SUNDRY NOTICES AND REPORTS ON WELLS
Do not use this form for proposals to drill or to re-enter an abandoned well. Use form 3160-3 (APD) for such proposals.

1. Type of Well <input type="checkbox"/> Oil Well <input checked="" type="checkbox"/> Gas Well <input type="checkbox"/> Other	8. Well Name and No. NORTH MADURO UNIT 1
2. Name of Operator CIMAREX ENERGY COMPANY OF CO Contact: DAVID A EYLER Mail: DEYLER@MILAGRO-RES.COM	9. API Well No. 30-025-30267-00-S1
3a. Address 600 N MARIENFELD STE 600 MIDLAND, TX 79703	3b. Phone No. (include area code) Ph: 432-687-3033
4. Location of Well (Footage, Sec., T., R., M., or Survey Description) Sec 20 T19S R33E SENE 2310FNL 660FEL	10. Field and Pool or Exploratory Area GEM-MORROW (GAS)
	11. County or Parish, State LEA COUNTY, NM

Maduro North Federal Unit 1

**Permanent Abandonment of Federal Wells
Conditions of Approval (LPC Habitat)**

Cimarex Energy Co. of Colorado
Maduro North Federal Unit 1

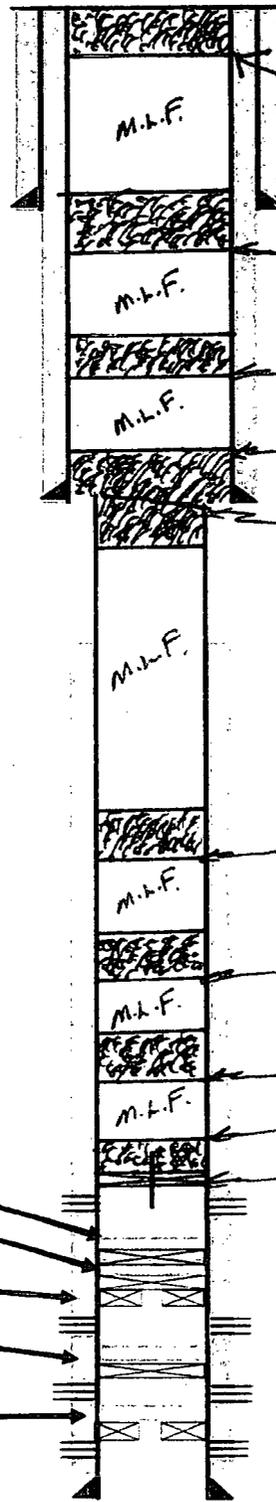
1460 - 1860 Tag

Below ground level marker required

**** BLM REVISED ** BLM REVISED ** BLM REVISED ** BLM REVISED ** BLM REVISED ****
